**Re: Request for Information Regarding Montana Air Quality Permit (MAQP)
#5200-00**

Tintina Montana Inc. (Tintina) is submitting this response to the Montana Department of Environmental Quality (Department) request for additional clarification issued for the proposed Black Butte Copper Project (BBCP) MAQP application on May 8, 2018. Each of the Department's requests for information is itemized below with a response.

FIGURE 1.3
Facilities Site Plan
Black Butte Copper Project
Mine Operating Permit Application
 Meagher County, Montana

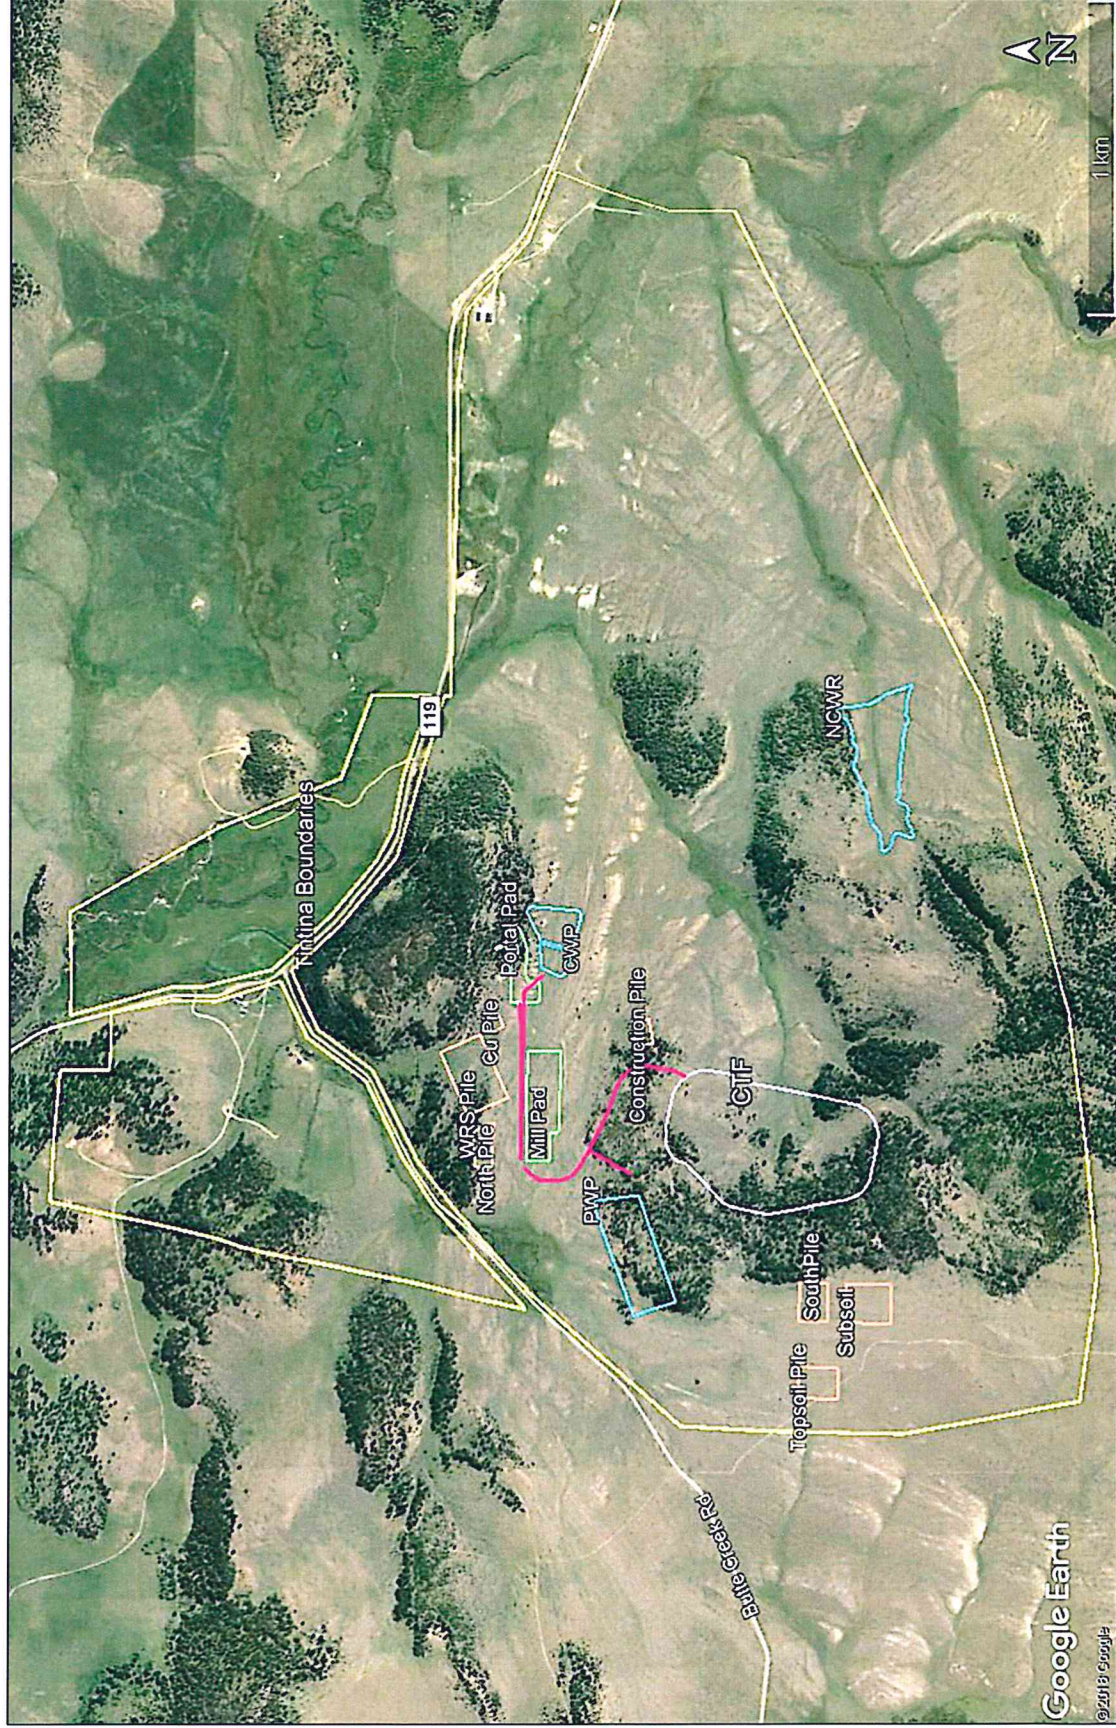
3. Discrepancies were found between the modeled road lengths and the road lengths in the "Road Dust Design Values" (Rddv) worksheet. The road length differences are summarized in the table. The Department did not total the emission differences for all of these road segments but have two specific examples as to how this impacts a couple of the road segments. Please confirm whether the road segments modeled are indeed the correct lengths and whether the Road Dust Design Values are in error.

Some of the road segments drawn into the model are longer or shorter than the Rddv segment lengths because the model segments are based on a spatial approximation of the BBCP facility layout as defined by Figure 1 of the BBCP MAQP application. The BBCP Facilities Site Plan is also included as Figure 1 with this response. Figure 1 was georectified for input into the BEEST User Interface and road segments were drawn to provide a best representation of the estimated roadway configuration of the facility within AERMOD. Model segments are intended to be relatively close to the lengths of the Rddv; however, Figure 1 is not drafted to exact technical specification. Model road segments had to be shortened or lengthened to complete road connections within the model.

Figure 2 – Haul Road Segment Locations Relative to Property Boundary
Displays the locations of Segments Rd_DAC, Rd_DCC, Rd_DCO, Rd17, Rd20, and Rd6.

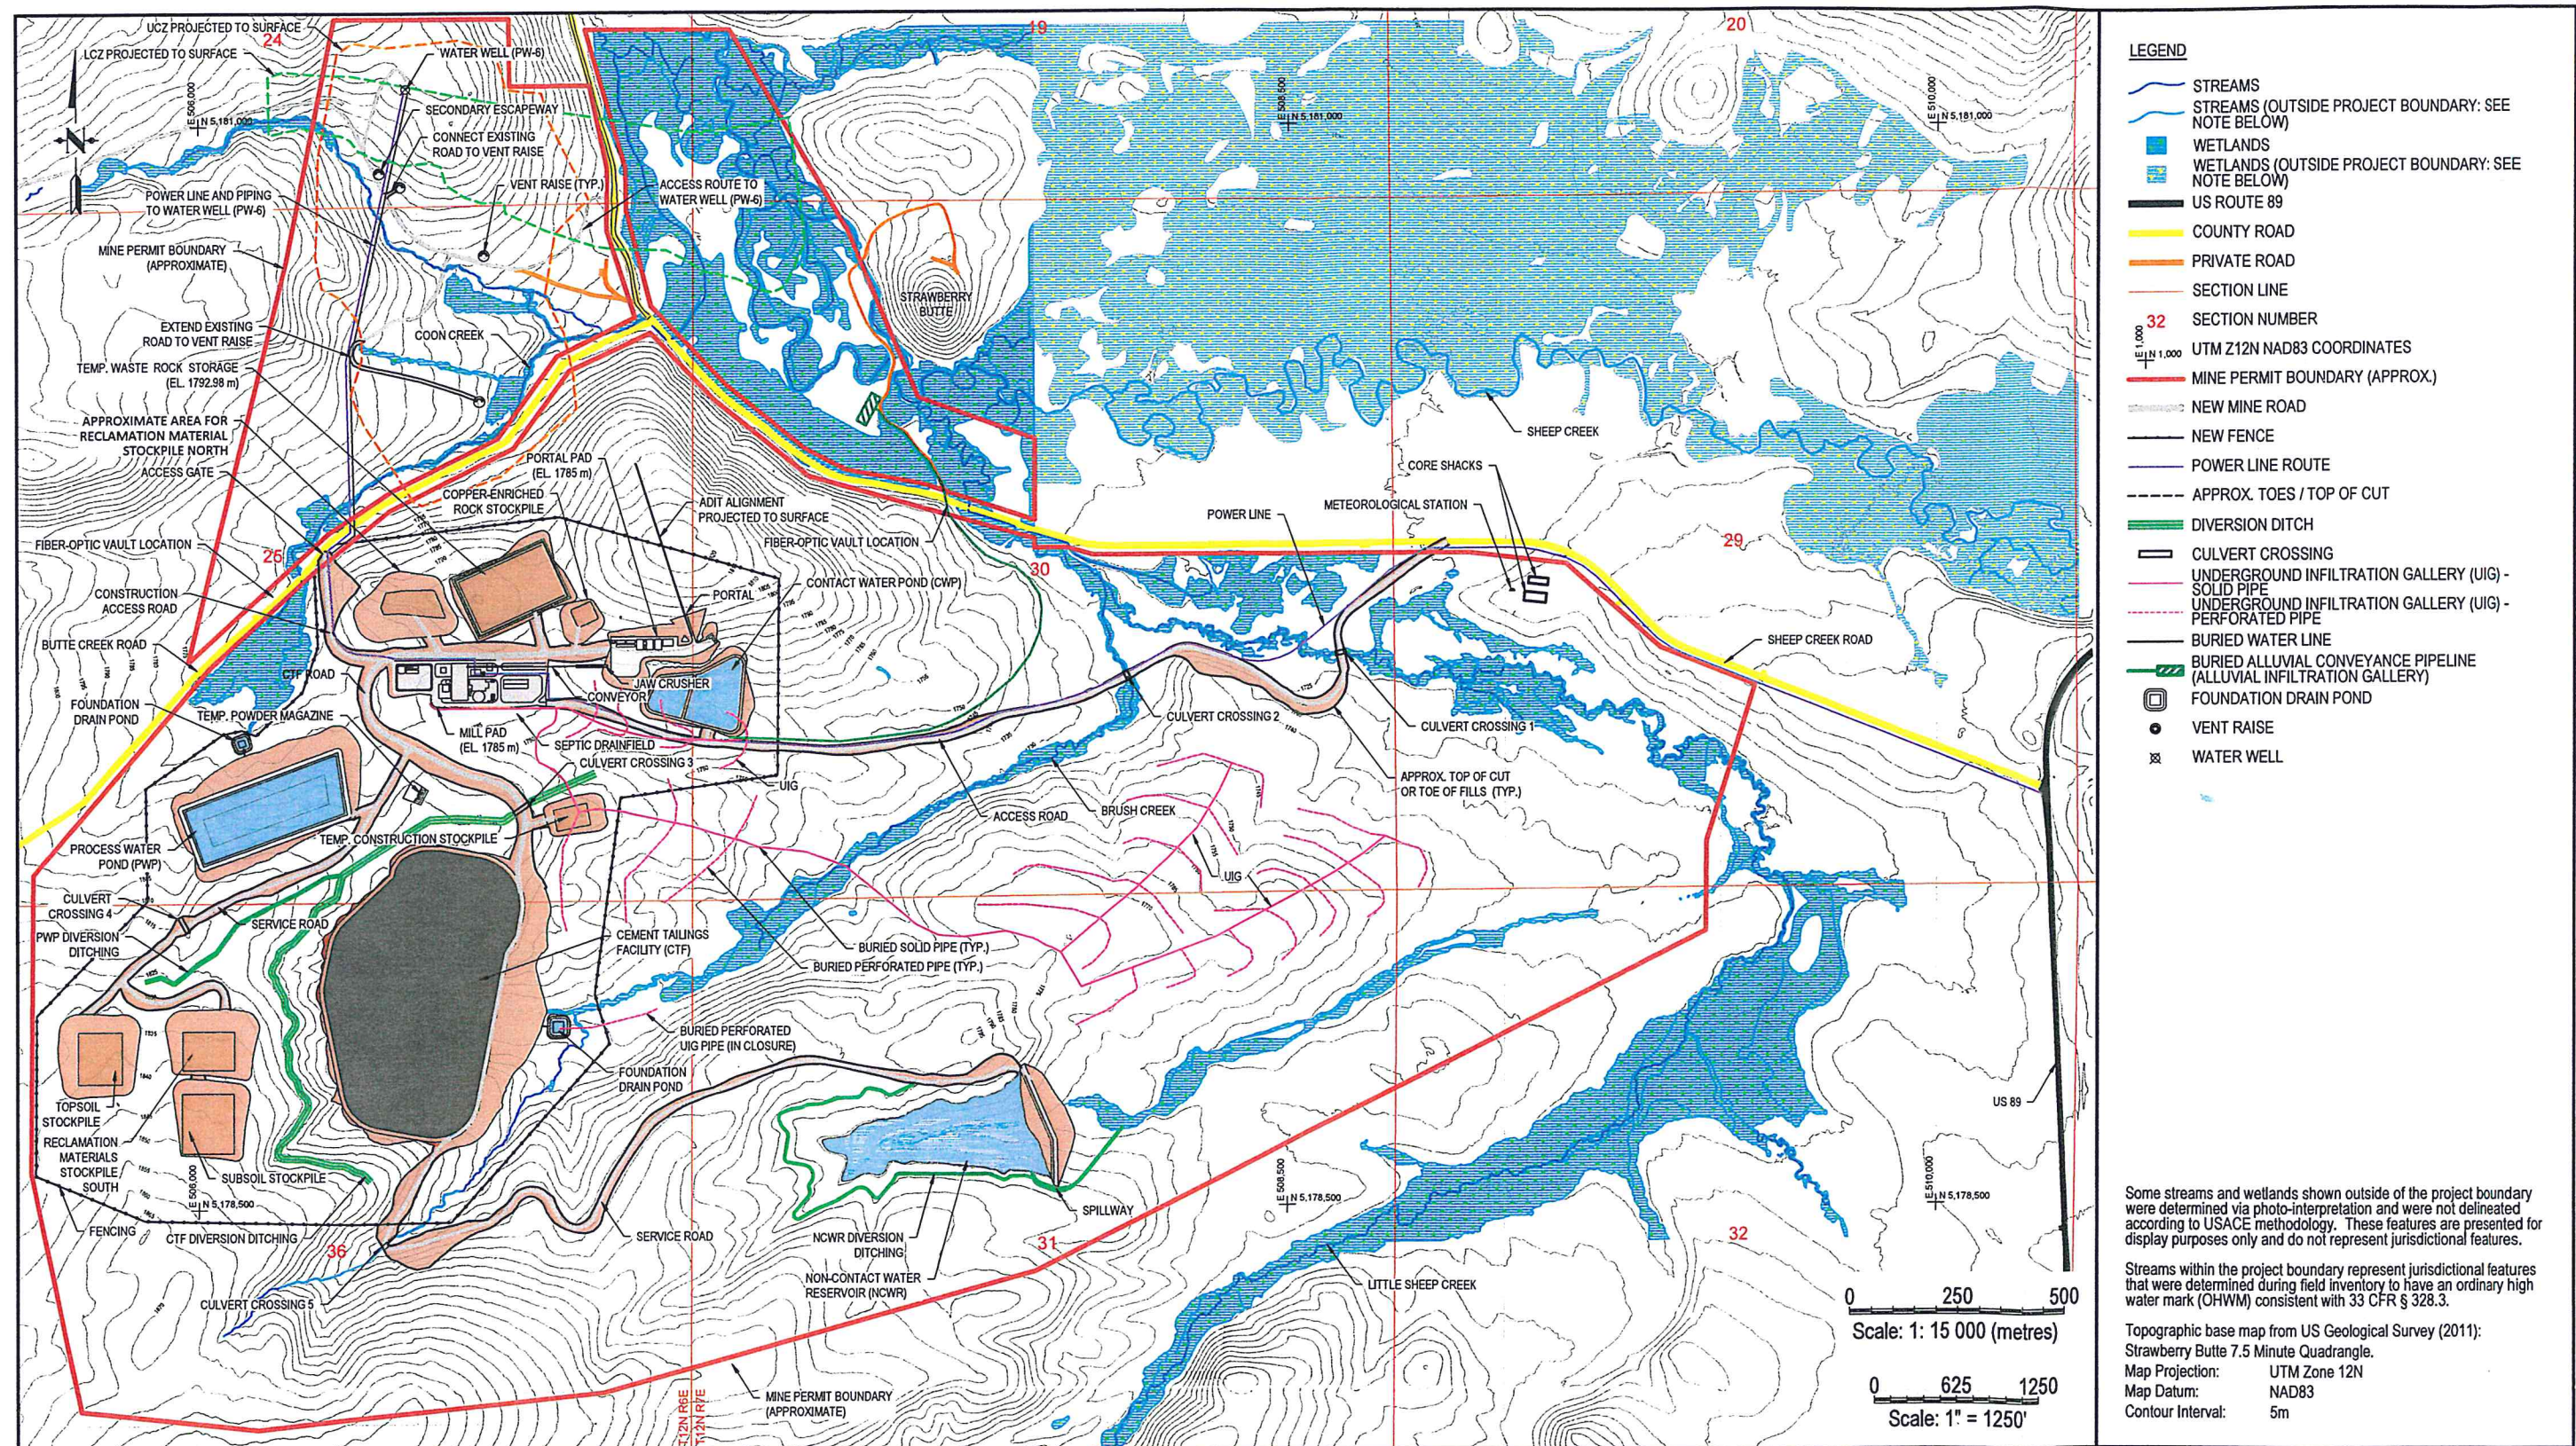
Additionally, road segments with the largest difference between the Rddv lengths and model lengths include segments Rd_DAC, Rd_DCC, Rd_DCO, Rd17, Rd20, and Rd6. These segments are located towards the interior of the BBCP property as segments Rd_DCC, Rd_DCO, Rd17, and Rd20 account for haul truck travel along the north mill roadway, Rd6 connects the mill pad to the main CTF road, and Rd_DAC connects the Cemented Tailings Facility to the Process Water Pond. A map showing these road segment lengths is included in the attachments. As the receptors with the highest impacts in the model are located on the edge of the property boundary and were primarily influenced by adjacent haul road emissions, the location and level of emissions attributed to these segments would not appear to drive model impacts with respect to the NAAQS. Thus, the variability in Rddv segment lengths and model segment lengths should be inconsequential to modeling results.

Response: The road lengths provided in the Emission Inventory “Road Dust Design Values” (Rddv) worksheet are based on the road length information provided in the July 2017 BBCP Mine Operating Permit Application (as referenced in the original February 20, 2018, MAQP application). The Rddv road lengths are the correct reference lengths for calculating emissions because they are design values developed specifically for expected hauling at the BBCP. As a result, all fugitive road dust emissions from haul trucks are calculated from the Rddv road lengths. The haul road fugitive source emissions are then applied to the road segments in the model. Regardless of the length of the respective road segments, all of the haul road fugitives are included in the model (emissions do not decrease based on how they are applied to the road segments, they are merely distributed).

The model road segments provide an approximation of the general location of the emissions calculated from the Rddv lengths. Slight variability in the length and routes of haul roads is inherent within the planning phase of earth work projects since the roads are not planned at a 100% fixed location such as a baghouse or other point source. Roadways can slightly change from the original design depending on the “on the ground” topography of the area during construction. An approximation of the general locations of the roadways in Figure 1 provides a best approximation of the areas to be impacted by haul roads. Consequently, these locations provide the best approximation for the location of associated haul road fugitive emissions.

The difference in length between the Rddv road segments and the model road segments only results in a difference in the distribution of emissions on a per volume source basis. Each modeled road segment has attributed volume sources spaced the expected length of a haul truck, 8.81 meters. Incongruencies between the Rddv lengths and model lengths can affect the apportionment of emissions to each volume source depending on the amount of volume sources attributed to a road segment. If a Rddv length is greater than

a model segment length, then there will be greater emissions per volume source than if the model length equaled the Rddv length. However, the total emissions do not change. So, the emissions are essentially more concentrated over a shorter model road length. Conversely, there will be less emissions per volume source if the Rddv length is less than the model segment length. Again, total emissions do not change so emissions are just less concentrated within the model over a longer modeled road length. The model road segments still provide the general location of the associated emissions within the facility and contain the correct total emissions for the haul road activity.
